Response to Information Request

Development Application for Material Change of Use – Multiple Dwelling (4 Units)

65 Stagpole Street, West End and formally identified as Lot 3 on SP338397

Information Request

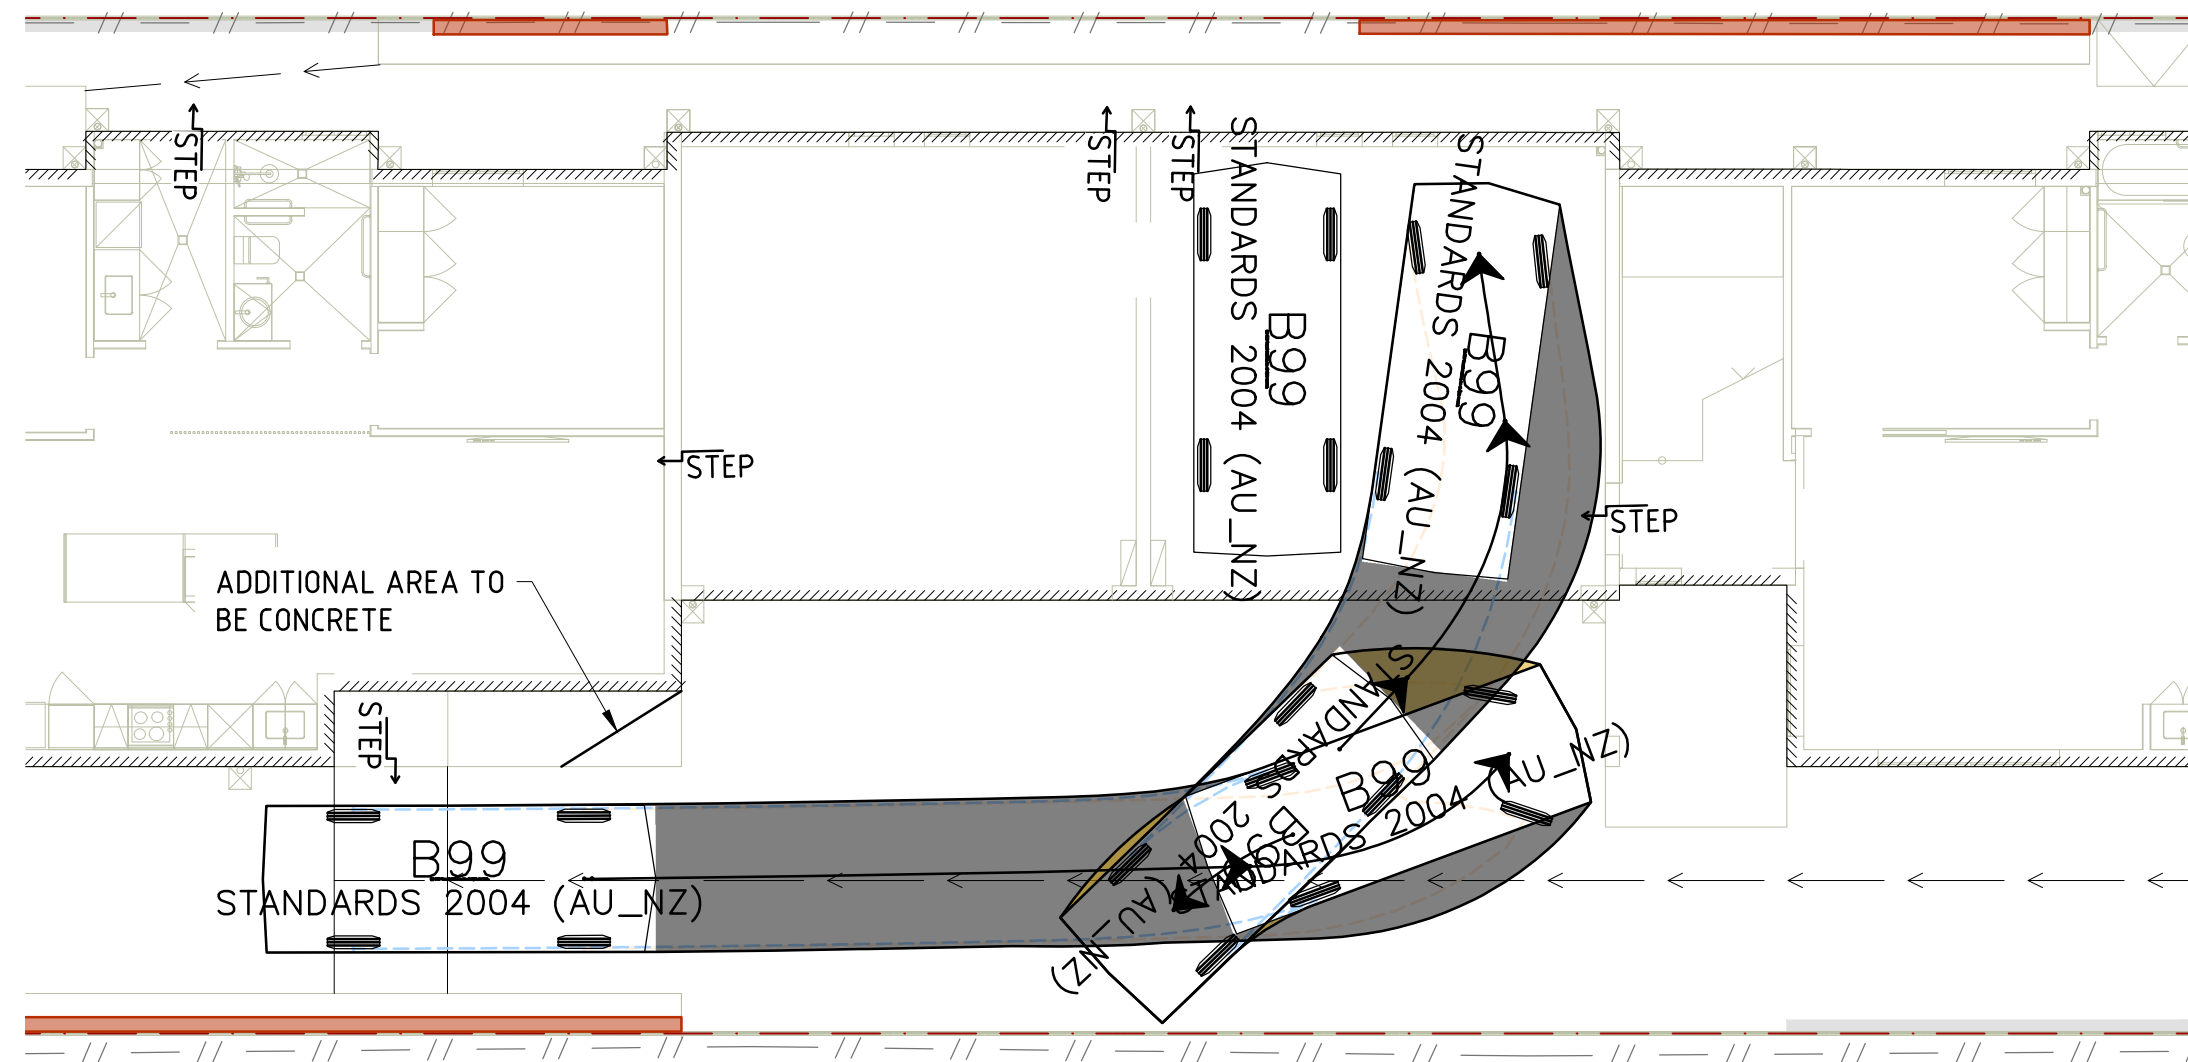
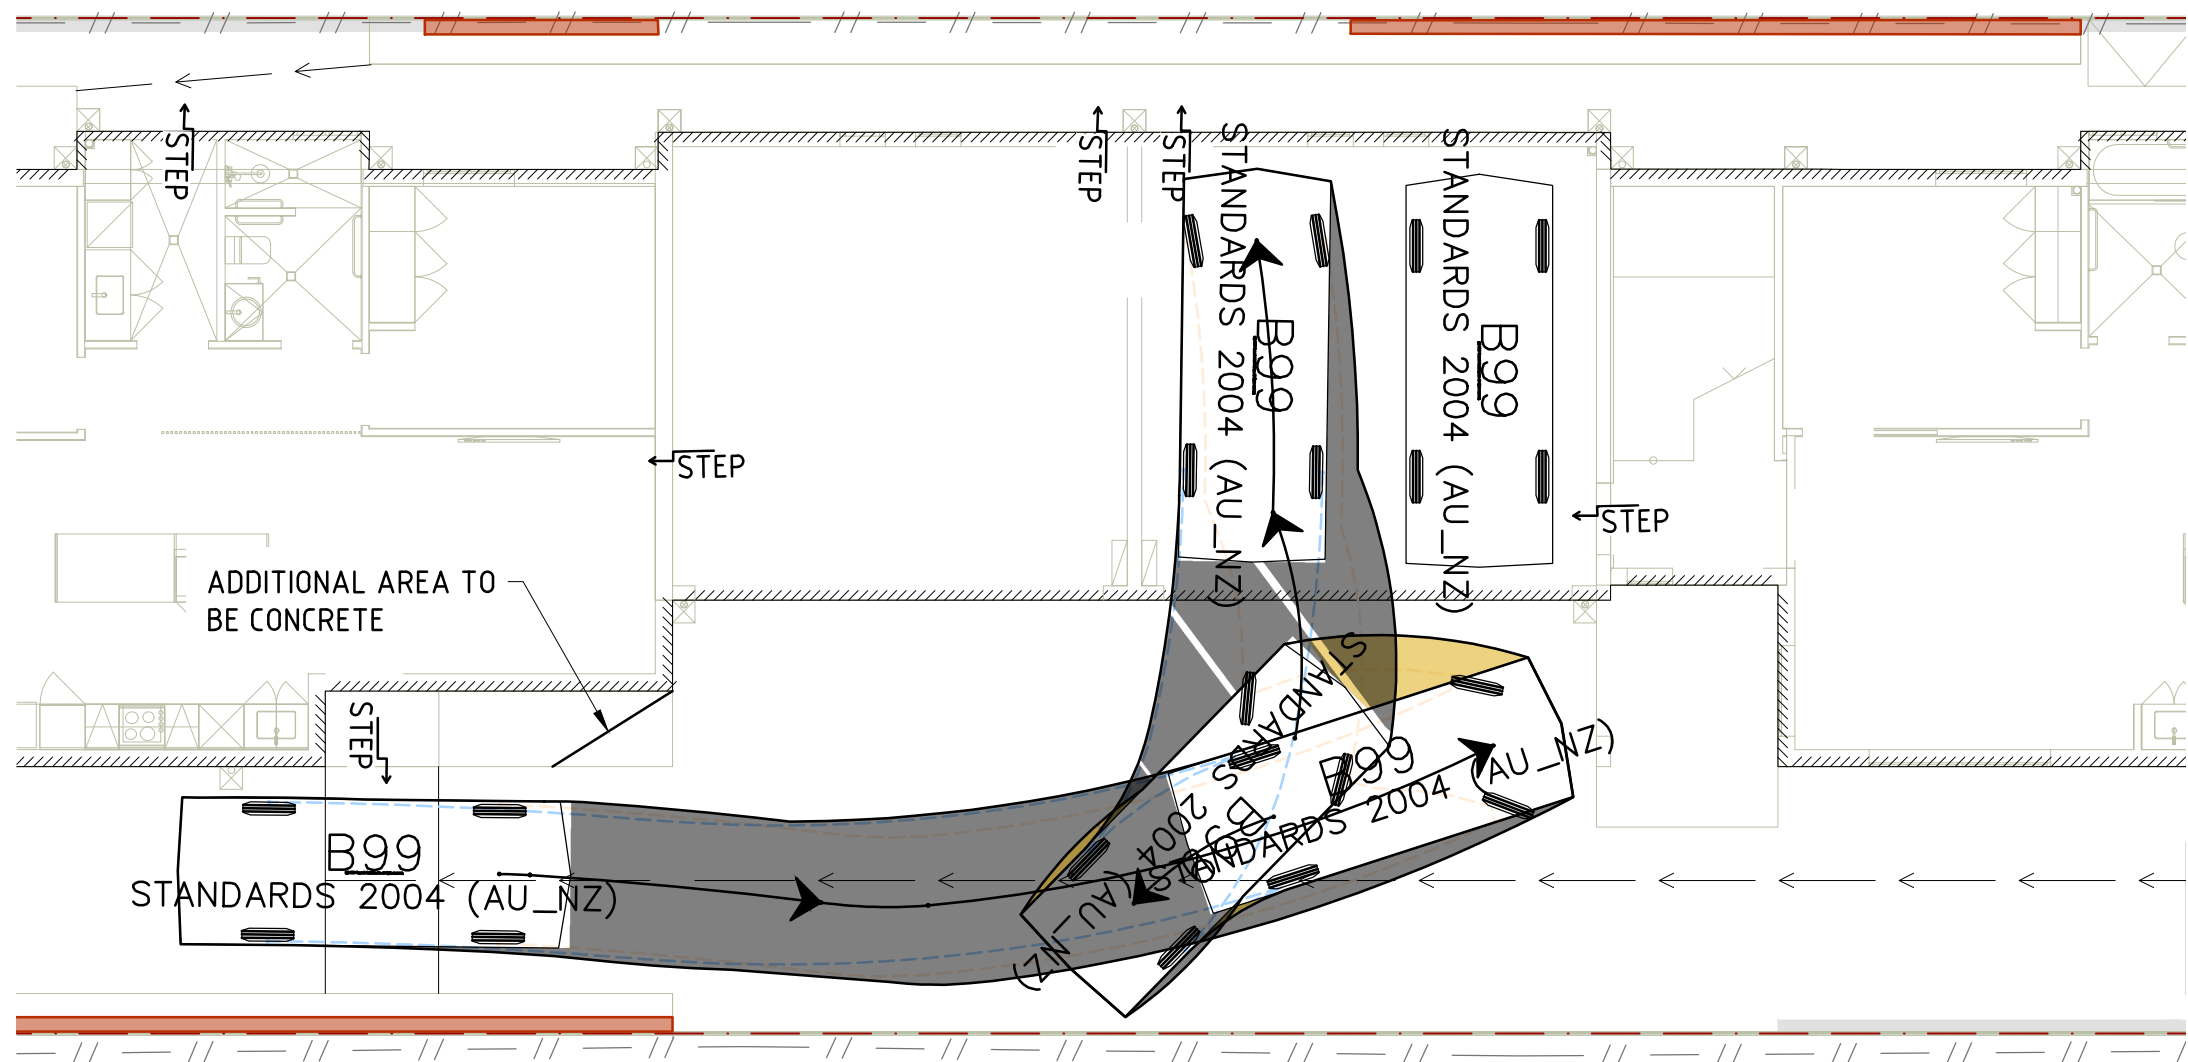
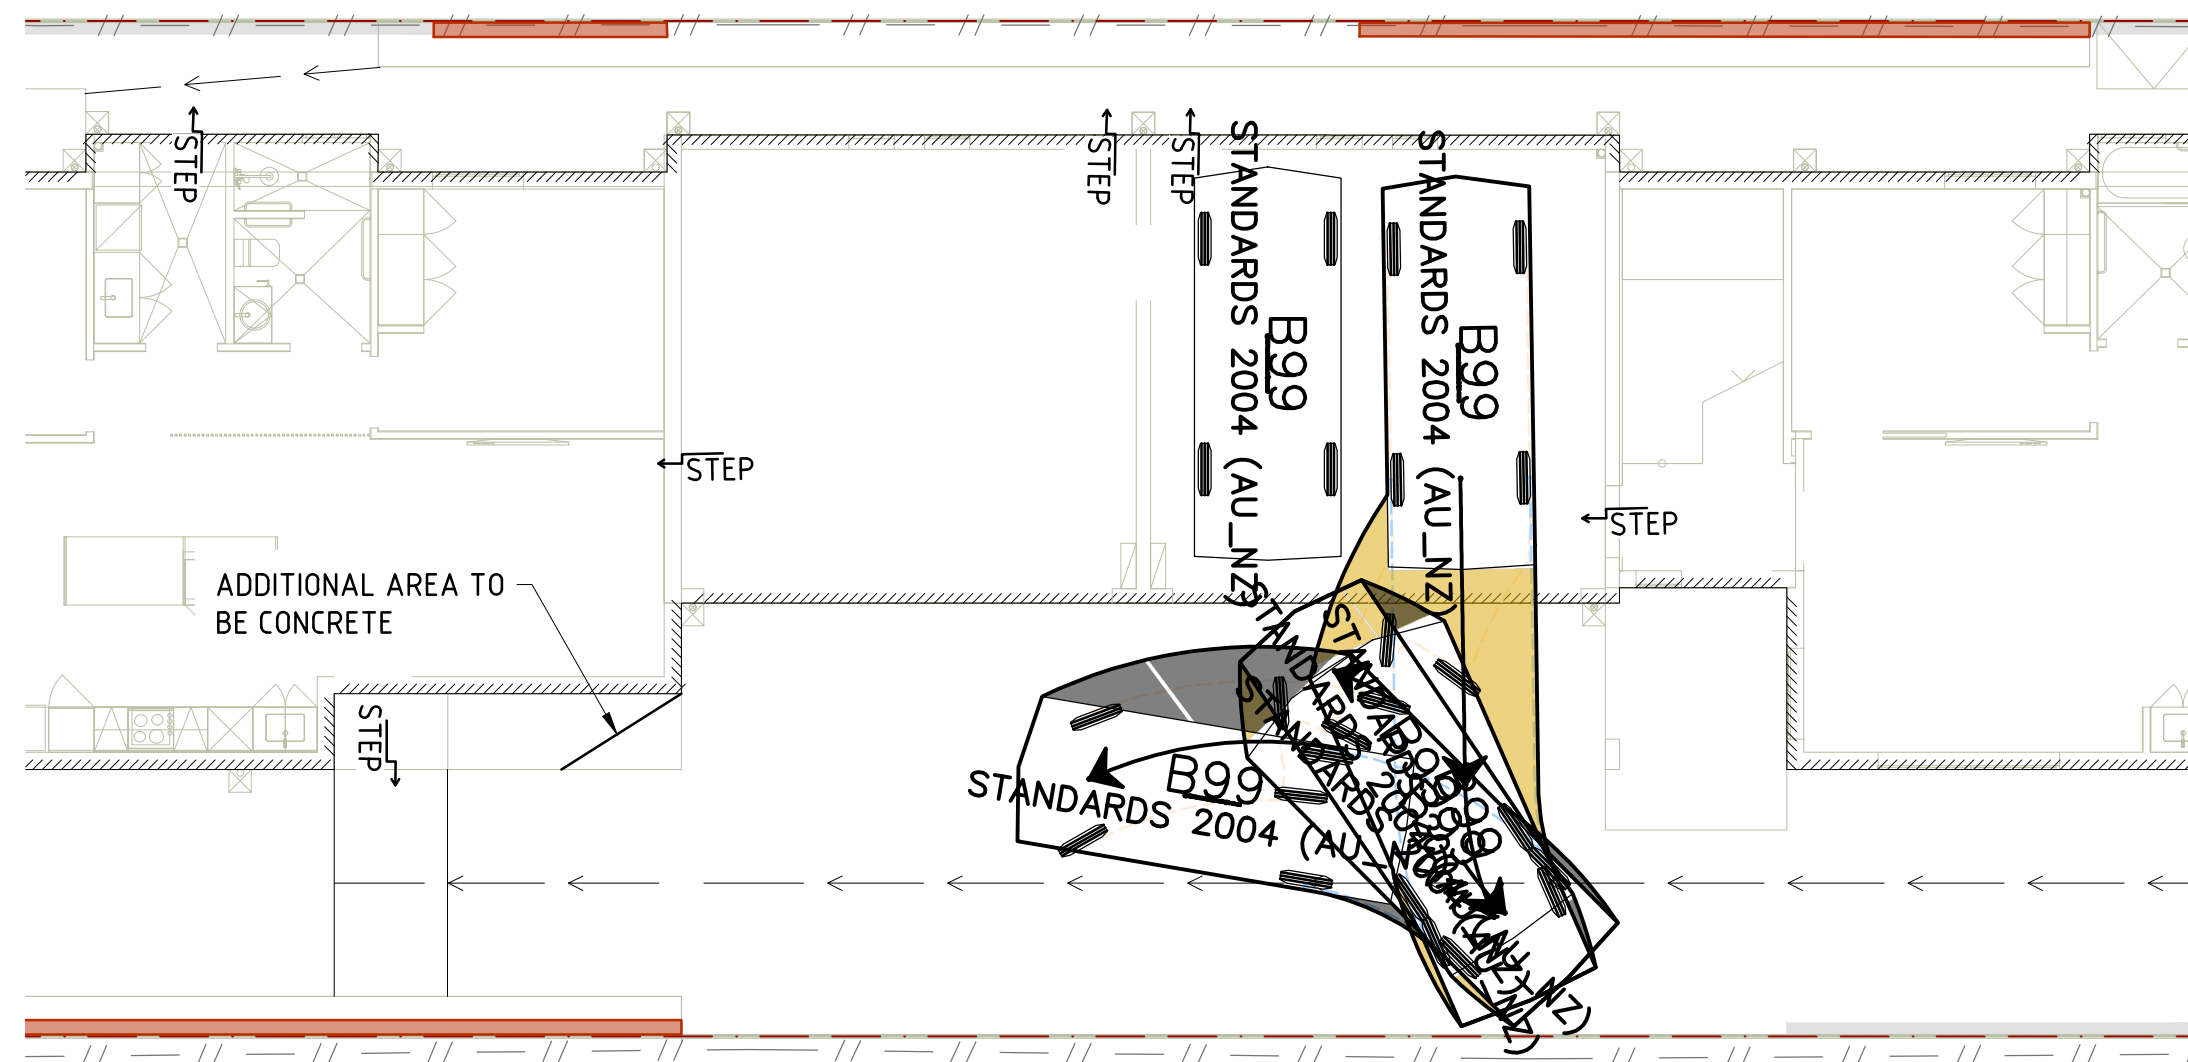
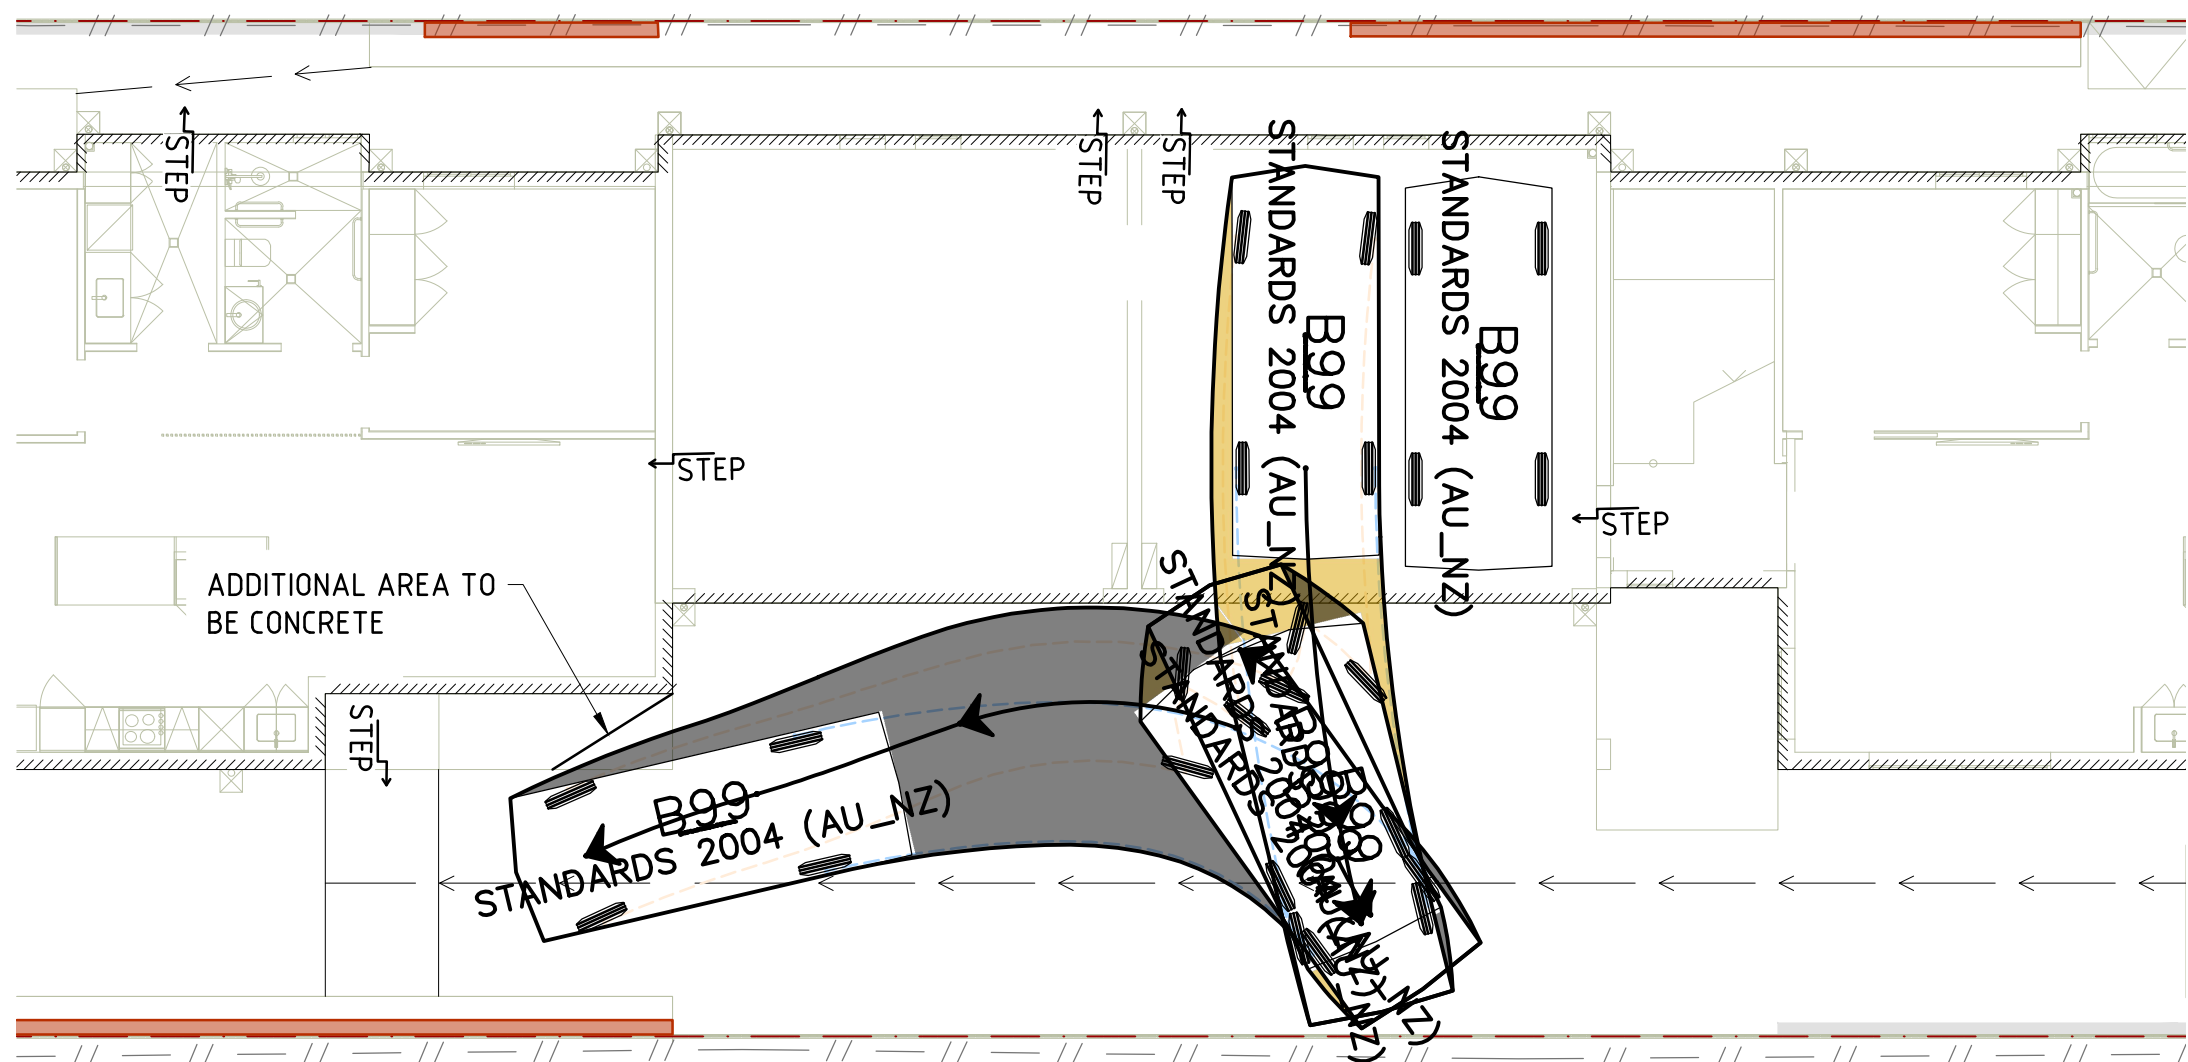
The exit motion appears to be restricted for vehicles exiting carpark 1, 4 and the visitor and possibly obstructed by the porch access and the garden located on unit 1 external wall.

In response to this item, please find vehicle swept path plans prepared by STP Consultants at **Attachment 3**. It is considered the provided plans suitably demonstrate that passenger vehicles can efficiently and safely enter and exit the site and manoeuvre within the proposed internal carparking areas.
